Australian Turf Club and Sydney's Light Rail project: Urban Impact Summary document- 18.12.2013

Sydney's Lightrail: Impacts Summary Sheet

CBD & SOUTH EAST LIGHT RAIL PROJECT

**Impact Plan 01
Spectator Precinct**

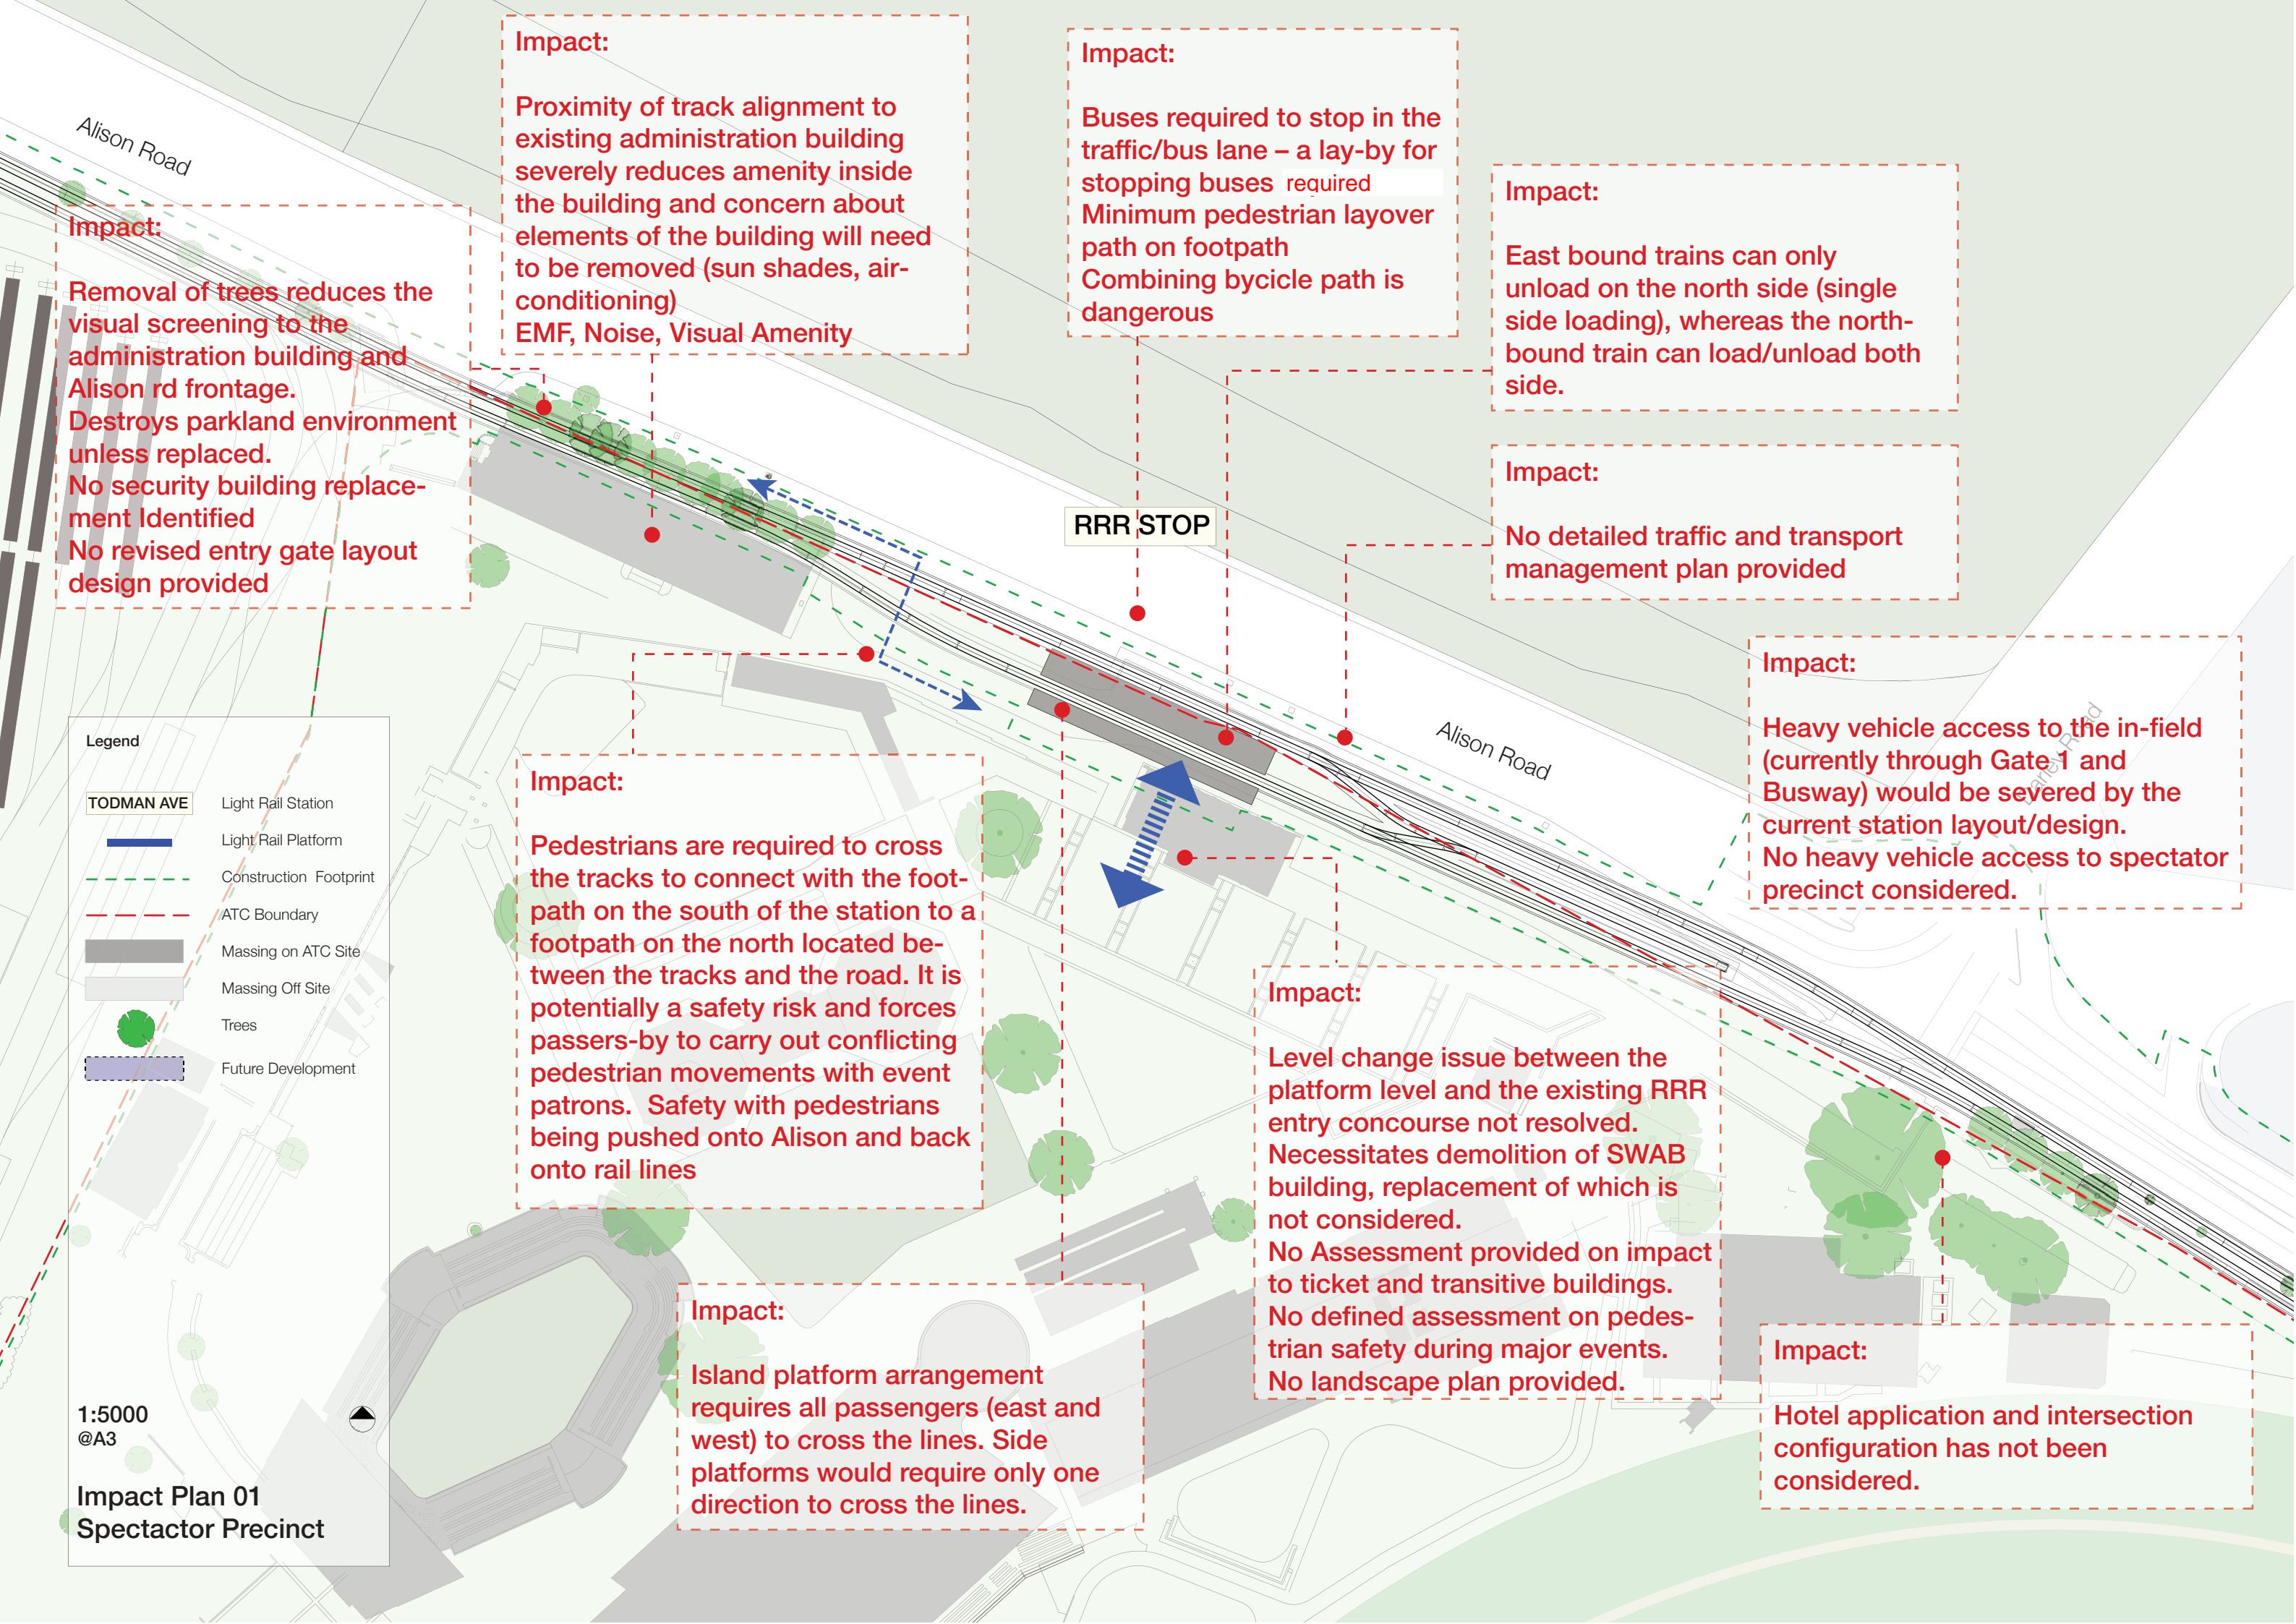
No detailed traffic and transport management plan provided

Level change issue between the platform level and the existing RRR entry concourse not resolved.
Necessitates demolition of SWAB building, replacement of which is not considered.
No Assessment provided on impact to ticket and transitive buildings.
No defined assessment on pedestrian safety during major events.
No landscape plan provided.

Removal of trees reduces the visual screening to the administration building and Alison rd frontage.
Destroys parkland environment unless replaced.
No security building replacement Identified
No revised entry gate layout design provided

Impact Plan 02
Wansey Rd Stop

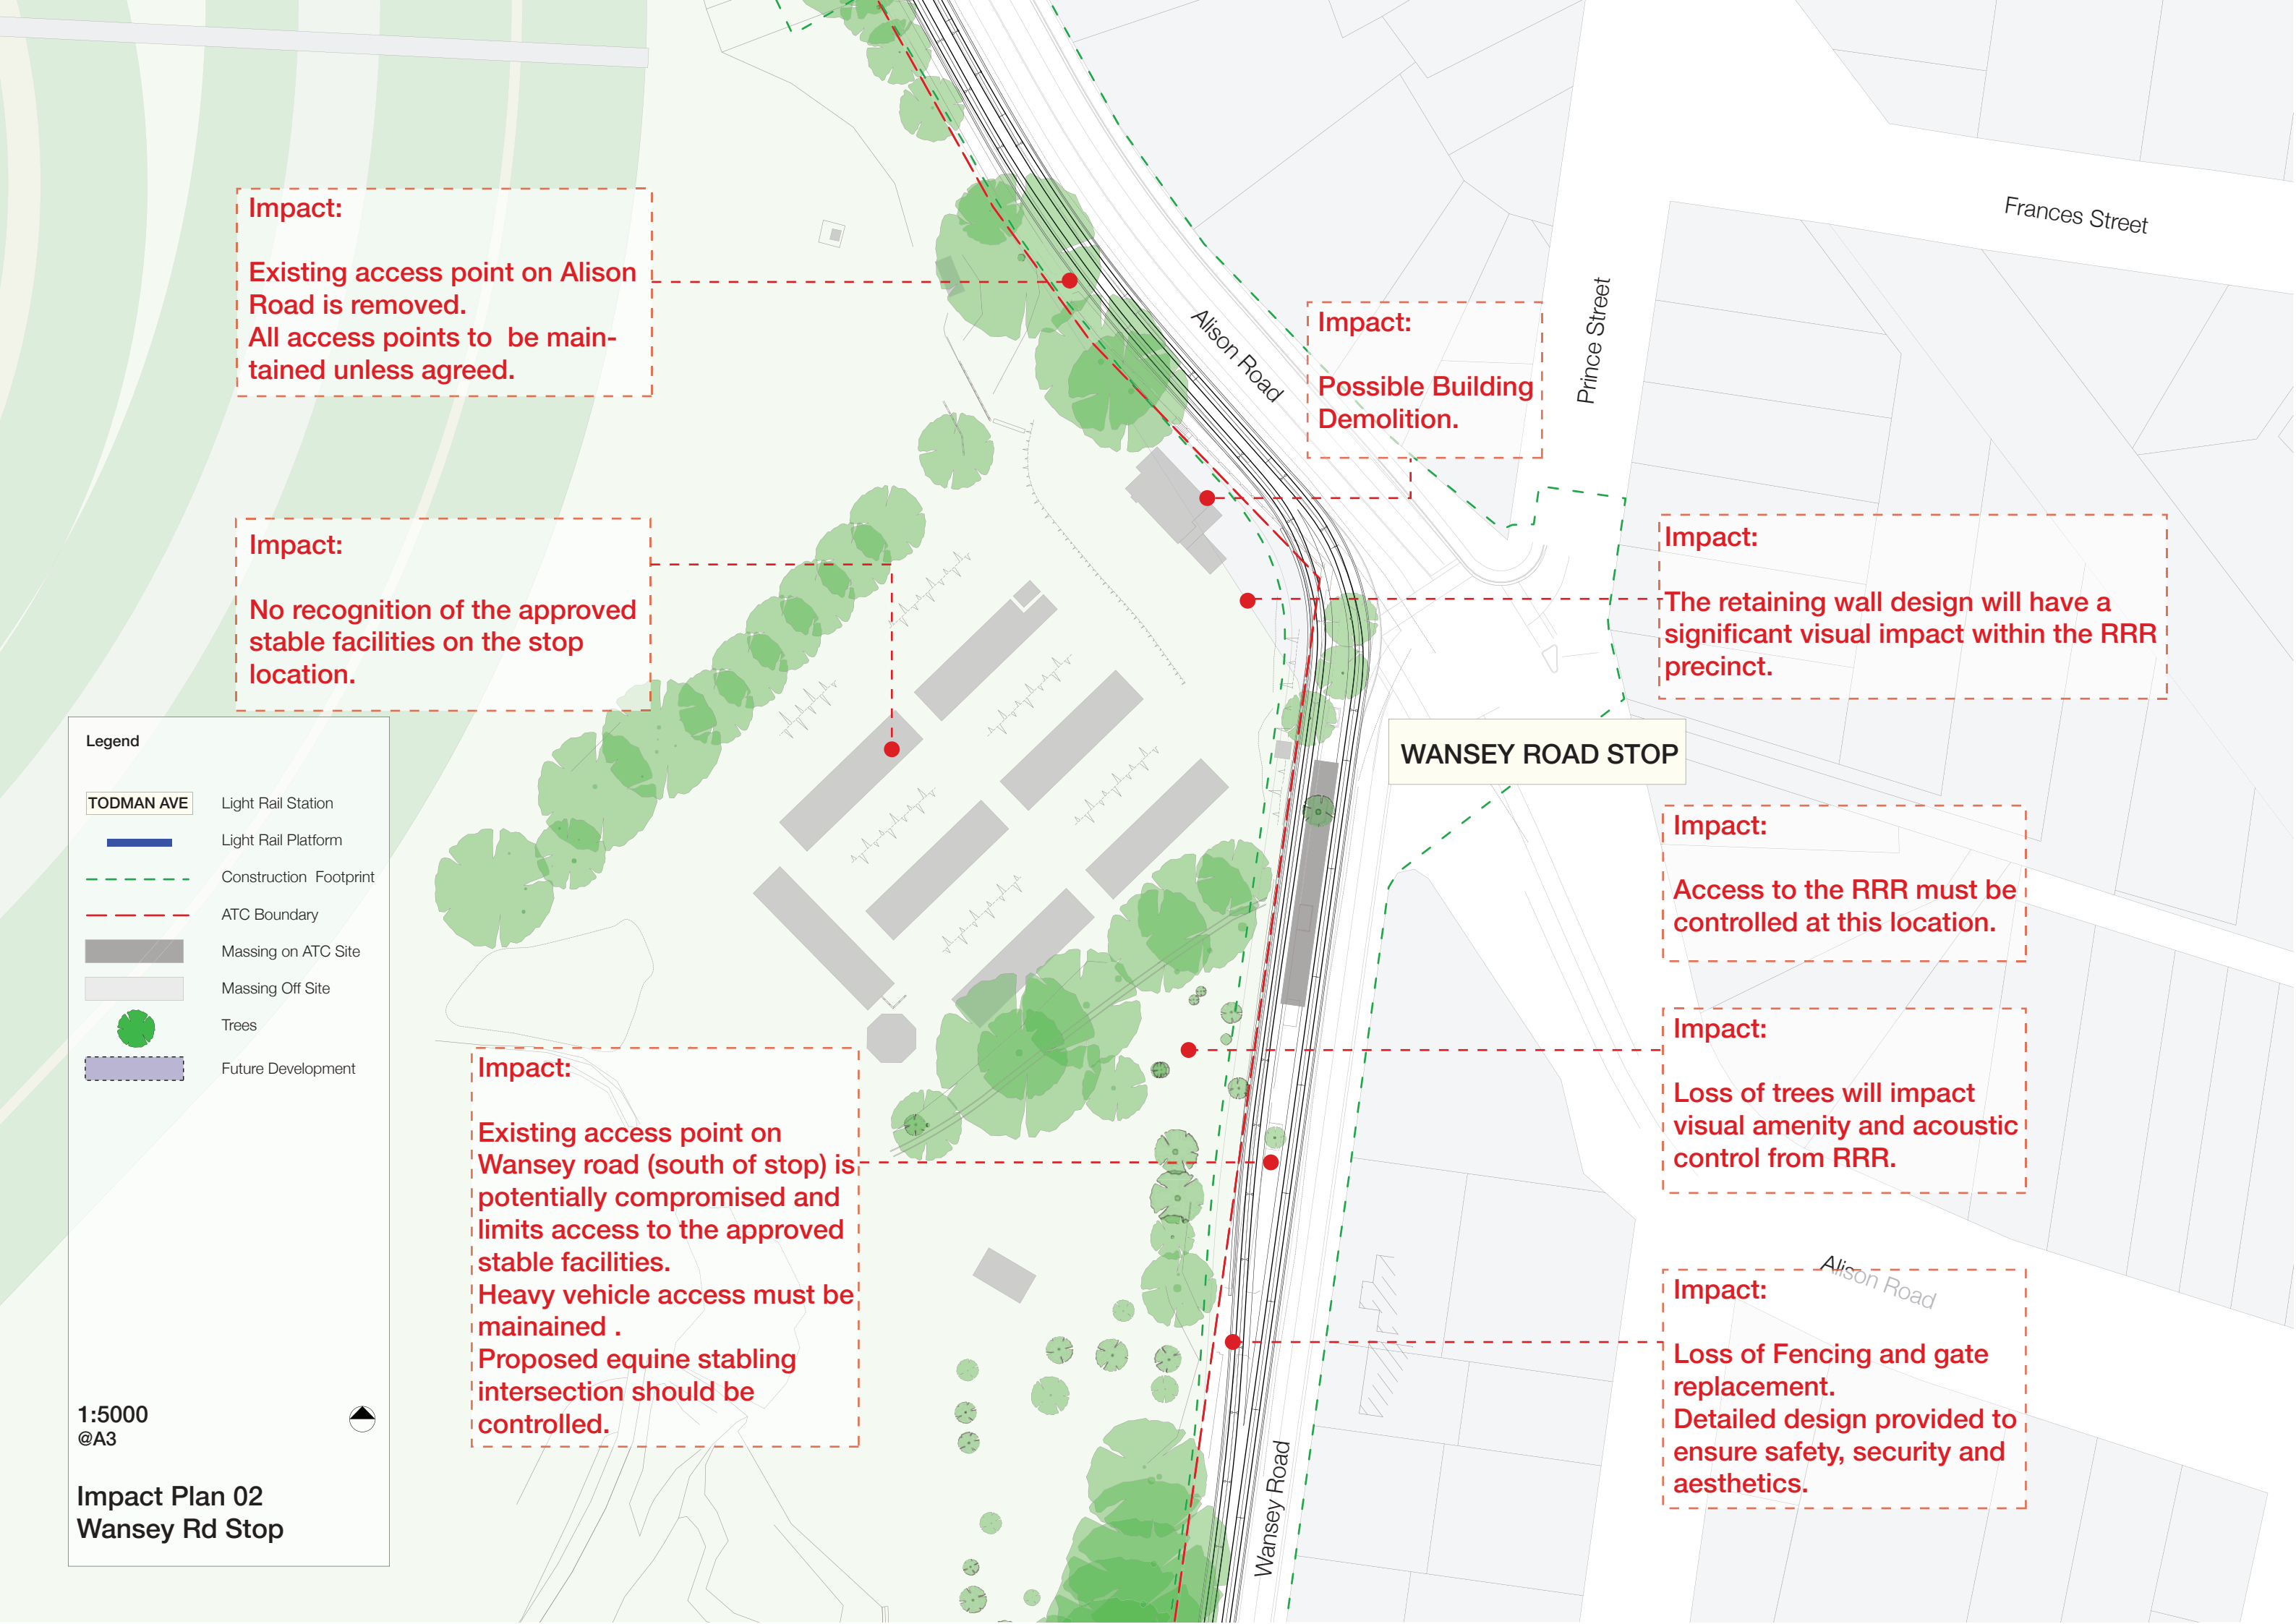
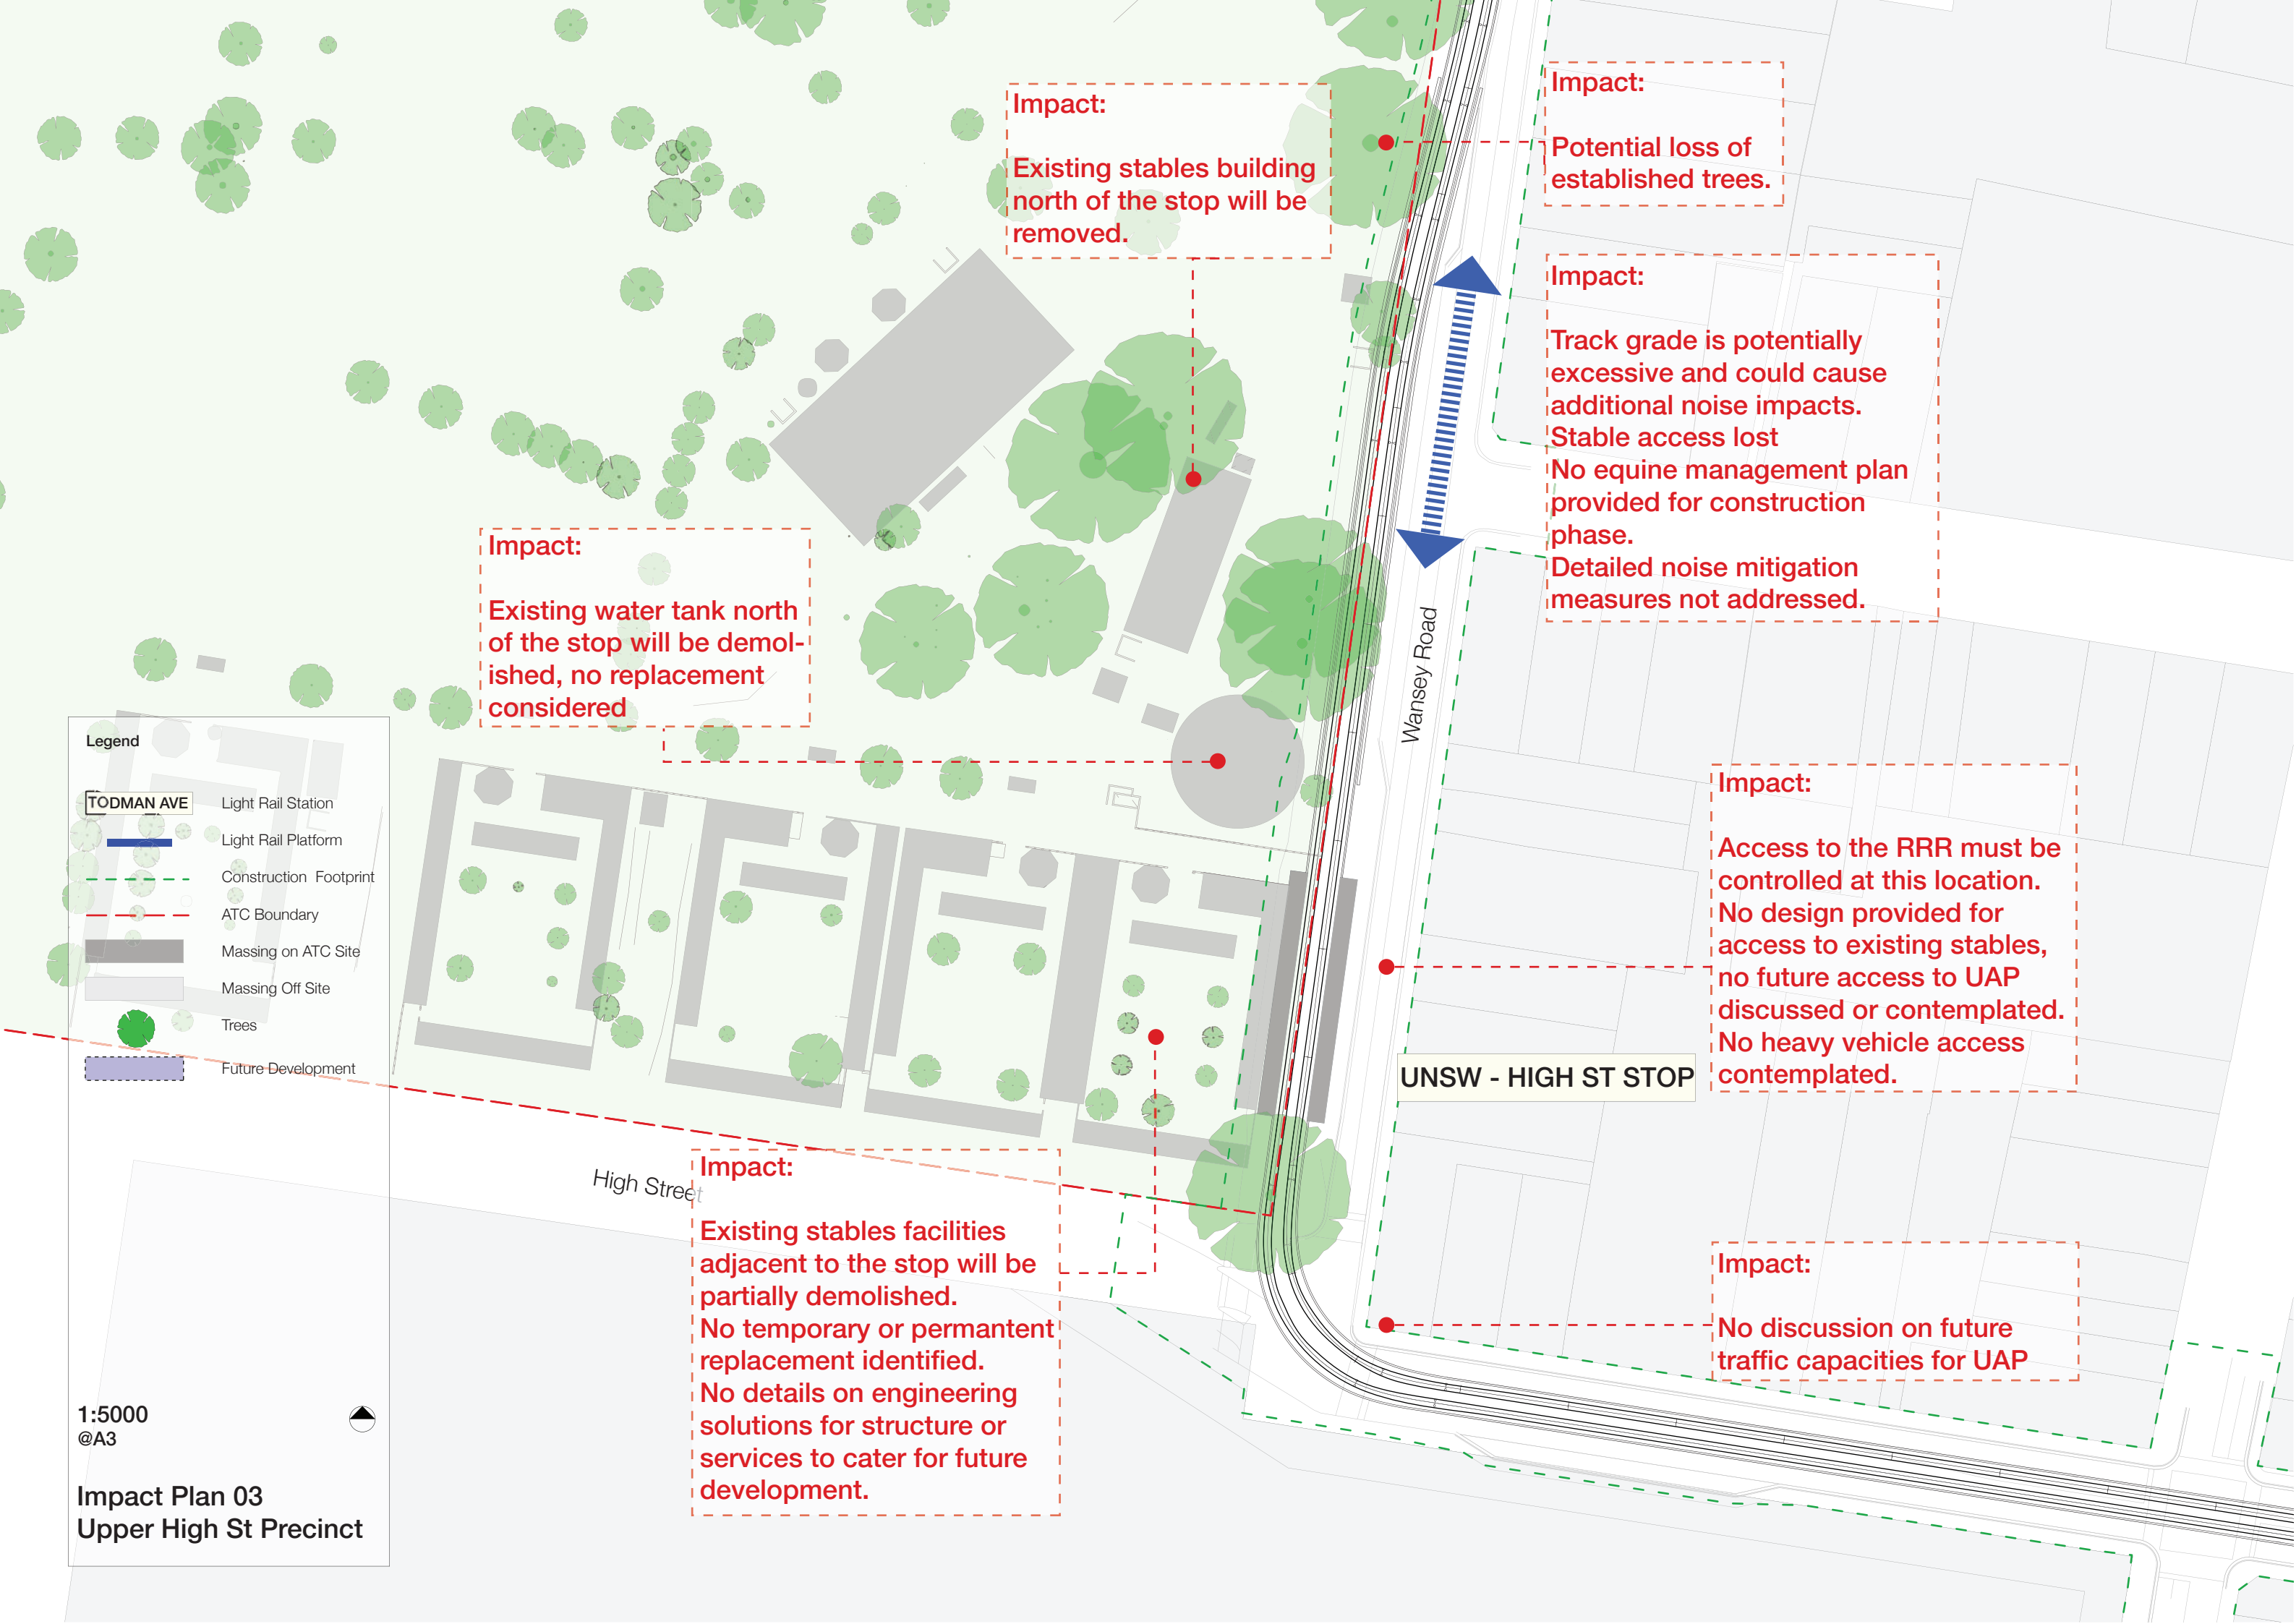
Track grade is potentially excessive and could cause additional noise impacts.
Stable access lost
No equine management plan provided for construction phase.
Detailed noise mitigation measures not addressed.
